AOS: Stray Light Control (SLC)-Output Faraday Isolator
FDR Responses

This document presents responses to the review committee for the Final Design of the Output Faraday Isolator (OFI), a component of the AOS Stray Light Control subsystem for aLIGO.

Figure 2: HAM optics table Seismic Motion, Displacement DOFs

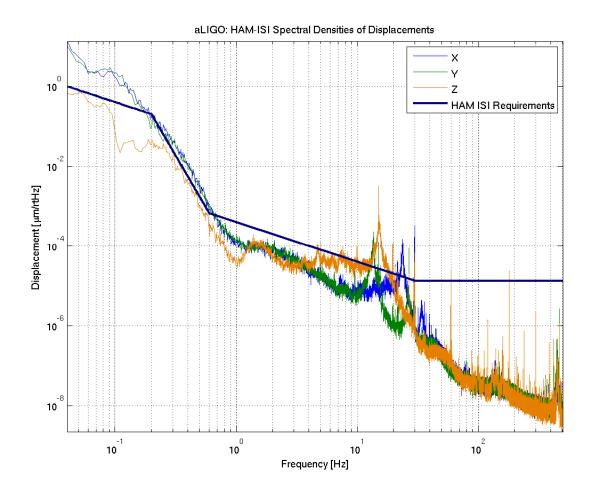
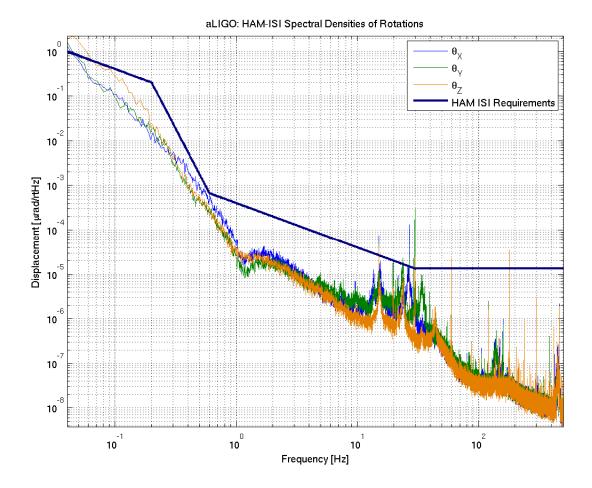
• Evaluate the noise not only for the current HAM ISI performance, but also for the ISI noise requirement level.

Evaluate the noise assuming that the isolation for a given DOF bottoms out at a value of 40 dB at higher frequencies

The seismic motion of the HAM ISI optical table at LLO in the six DOF is described in T0900285-v1 and is shown below.

Figure 7: HAM-ISI yaw Θ_z coupling y_I , and y_2 along the beam direction due to the translation of the OFIS suspension.

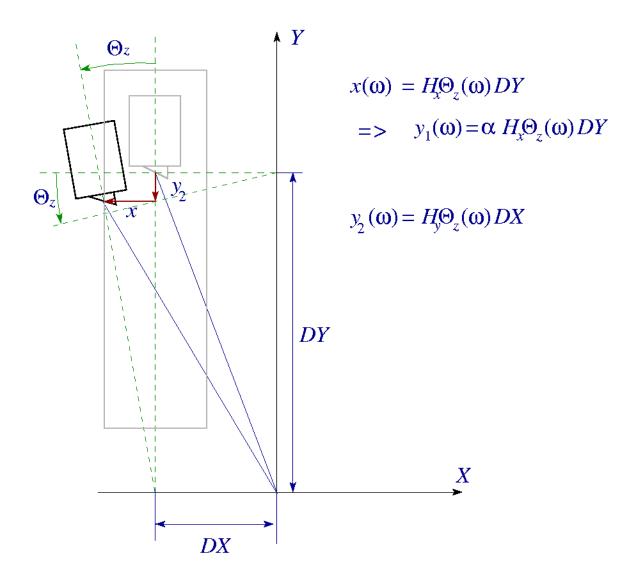
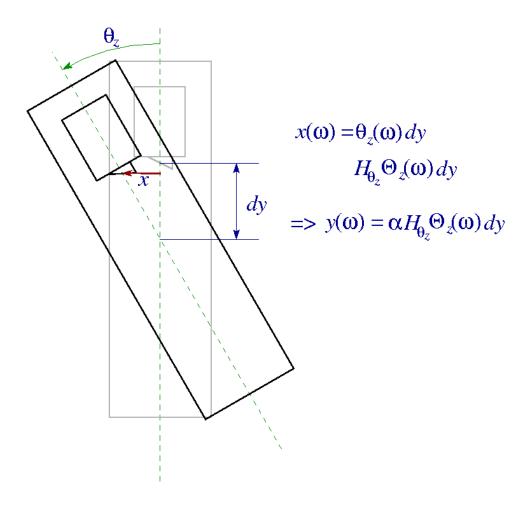
State what you are using for geometrical coupling factors.

The coupling depends on the location of the optical surfaces on the suspended platform.

The two figures below are two examples that show how one excitation couples into the beam direction. The other coupling mechanism were calculated using the same type of analysis.

Figure 16: Total OFI Scattered Light Displacement Noise

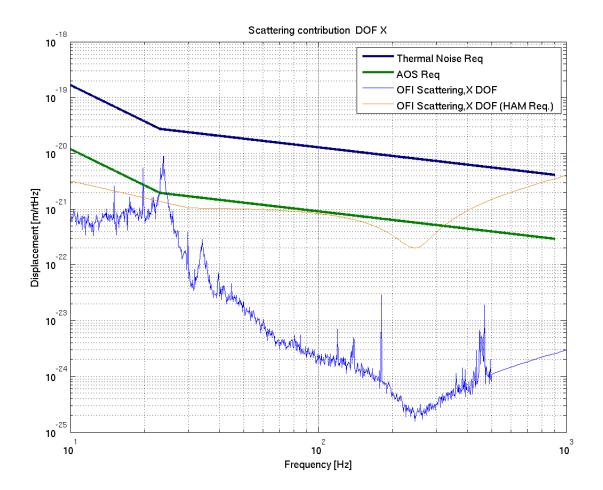
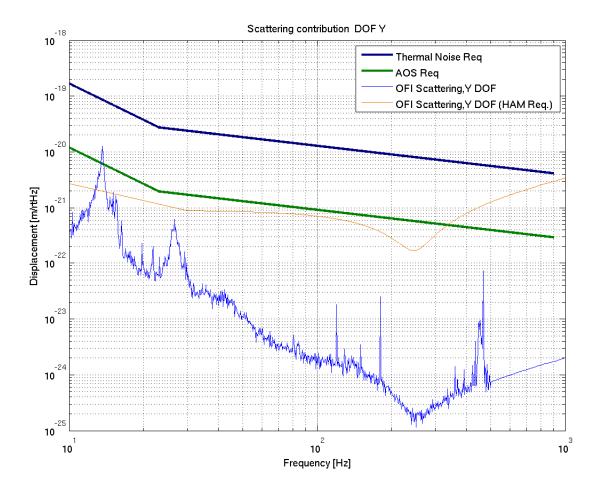
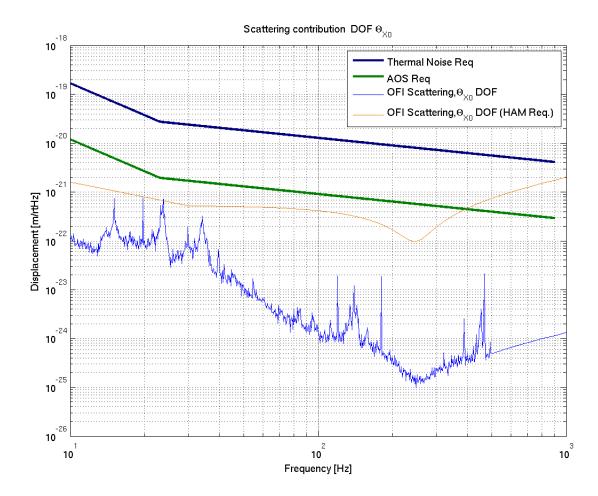
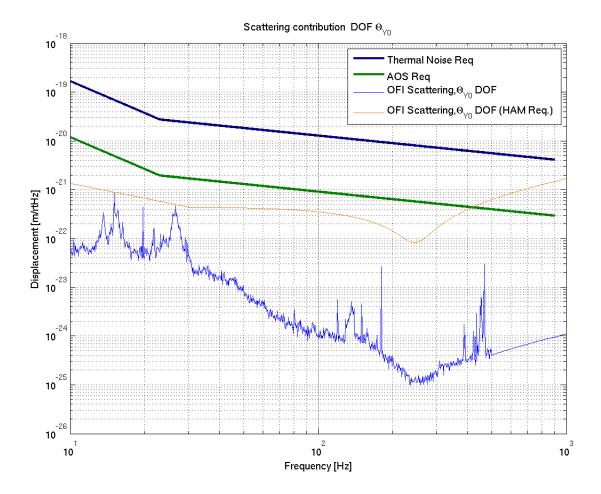
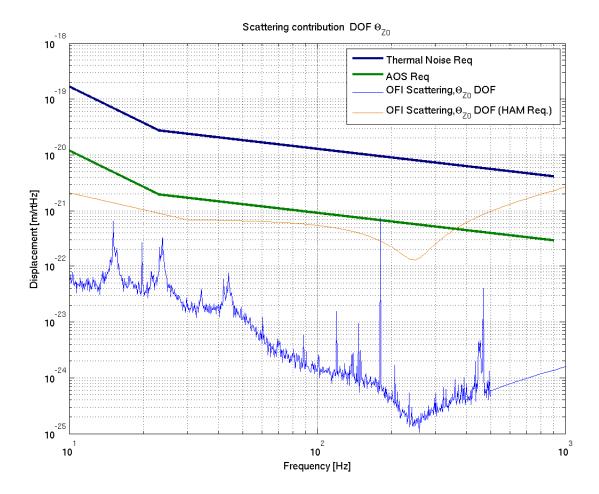
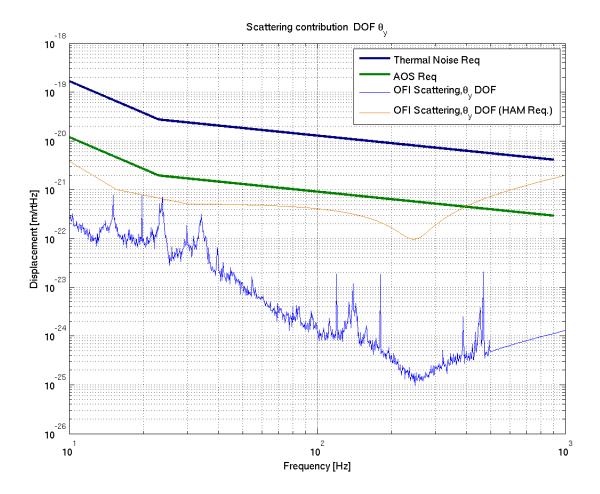
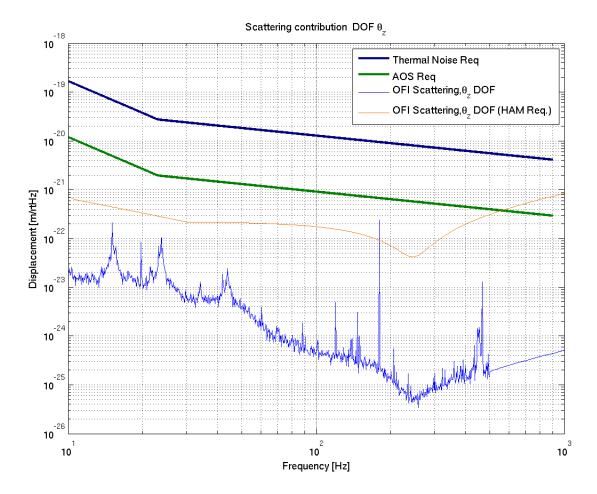
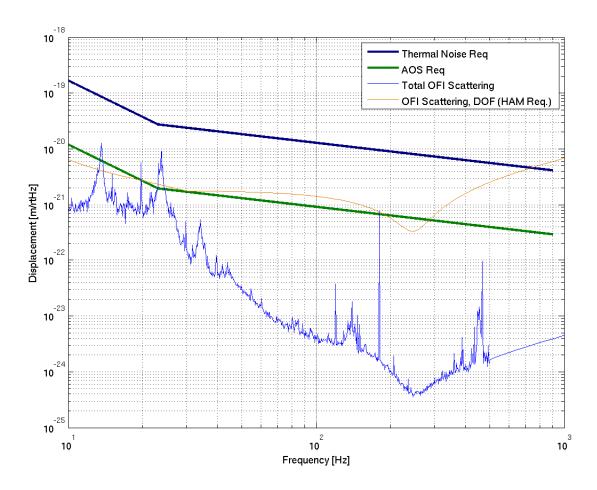
Evaluate the noise not only for the current HAM ISI performance, but also for the ISI noise requirement level.

Evaluate the noise assuming that the isolation for a given DOF bottoms out at a value of 40 dB at higher frequencies.

The Seismic motion amplitude of each DOF at the OFI was estimated by attenuating the measured HAM-ISI seismic motion with the measured transmissibilities of the OFI suspension prototype. The component of this residual seismic motion along the OFI optical axis was used to determine the back-scattered light displacement noise. See T1000190-v1.

Figure 17: Surface Reflections from OFI Dumped on Black Glass Plates

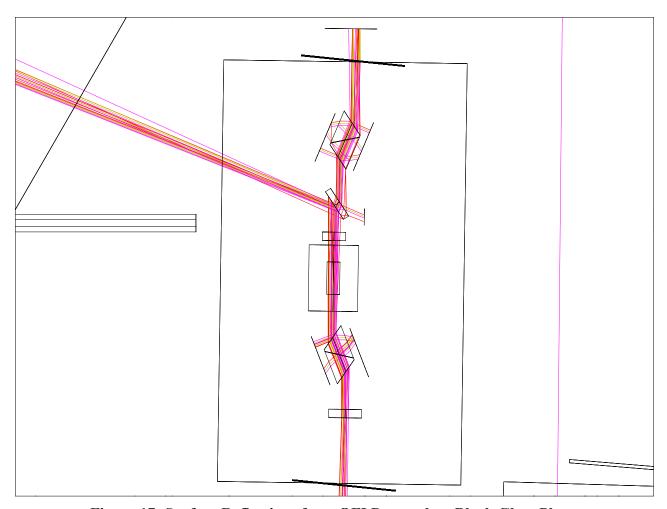
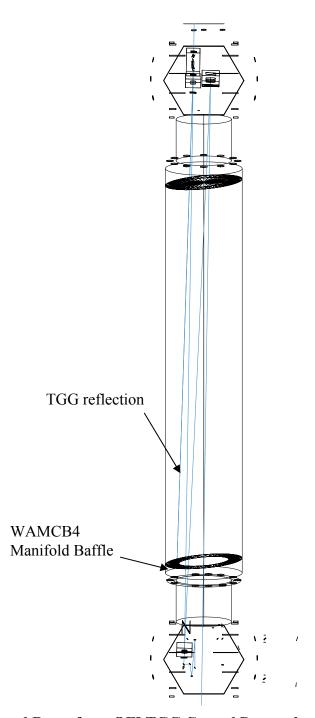
Also, indicate all first surface reflections from the OFI components and show how they are dumped.

The first surface reflection from the Brewster's prisms are caught on the near normal surfaces of the AR coated black glass beam dumps shown in Figure 17.

The first surface reflection from the TGG crystal will be caught and dumped on the WAMCB4 Manifold Baffle, as shown in Figure 18.

Figure 19: Lost Power in OMC due to Aberrations on the Input Beam

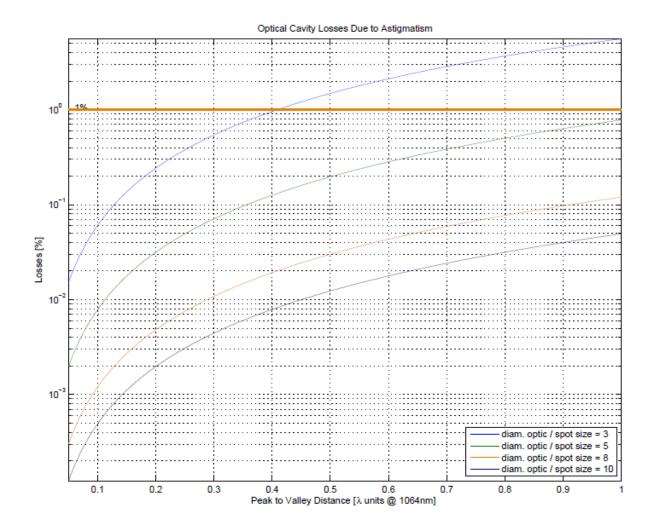
Wavefront distortion. The spec of < 1 lambda sounds pretty loose. Why is this believed to be adequate? Please consider the impact on mode-matching to the fundamental mode of the output mode cleaner. The rotator spec indicates that you received interferograms of the transmitted wavefront through the crystals, so your analysis could use these maps to analyze how much power is lost from the TEM00 mode.

We assume that the wavefront aberration is totally astigmatic. An overlap integral was calculated to determine the overlap of the aberrated wavefront with the TEM00 mode. The mismatched portion was considered to be lost to the OMC cavity. The OFI beam parameters are shown in Table 2.

The results of the coupling loss calculation are shown in Figure 19: Lost Power in OMC due to Aberrations on the Input Beam. Less than 0.4% coupling loss will occur with the actual aberrations of the OFI components.

Figure 20: Limiting Aperture of OFI

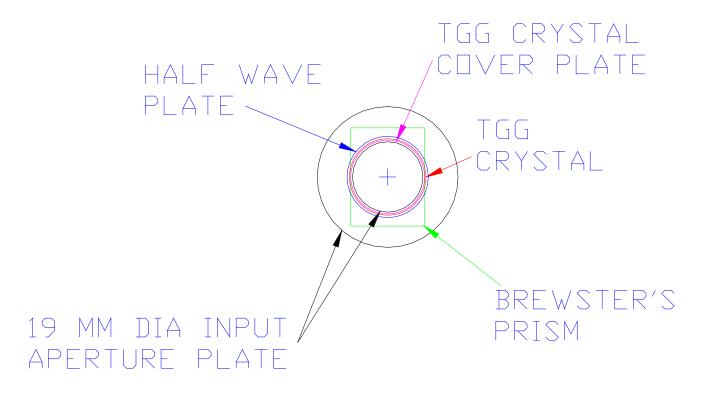
• Aperture: show a beam-on view of the assembly, with apertures marked. What is the limiting aperture and how is the beam outside this aperture baffled?

The diameter of the TGG crystal is 20.7 mm. The cover plate of the TGG crystal is 20 mm diameter. The aperture of the half wave plate is 22 mm diameter. The aperture of the Brewster calcite prisms is 27 x 20 mm.

The limiting physical aperture of the OFI is the 19 mm diameter of black glass input aperture plate. The black glass will dissipate the beam outside of the 19 mm diameter clear aperture.

Figure 21: Suspended Faraday Isolator

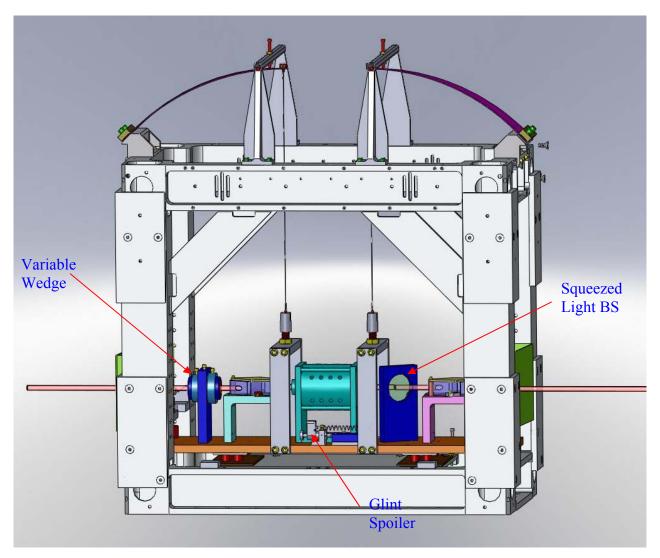
The committee would like to understand why the suspension design is as it is -- please review with us the considerations that went into the design, as it is shown in Fig. 2 of T1000181-v1 (not including the support structure, which we understand is a copy of the OMC suspension structure).

Based on the recommendations from the reviewers, a four-wire suspension has been chosen for the final design. It removes the so called bridge structures, which connected the platform to the blades through a single wire as shown in the figure. Elimination of the bridge changes the suspension from a double pendulum into a single pendulum, simplifying the suspension itself and improving the attenuation at low frequencies. The resonant frequencies of the prototype double wire prototype, OFIS-Proto2, were measured and the results compare favorably with the analytical model of the suspension.

Figure 22: Faraday Isolator Extinction Ratio as a Function of Input Beam Angle, in radians.

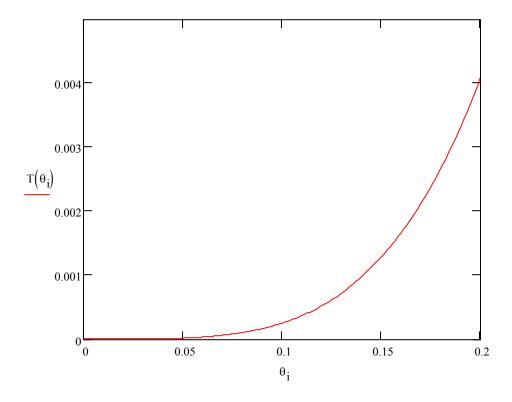
What is the tolerance on the angular alignment?

There is no data available from the manufacturer. However, an analysis was done to estimate the change in Faraday polarization rotation as a function of input angle. The results are shown below. The path length change through the TGG crystal as a function of input angle is given by

The input beam angle can vary by \pm 0.14 radians, which is \pm 8.5 deg, and still meet the 1000:1 extinction ratio requirement.
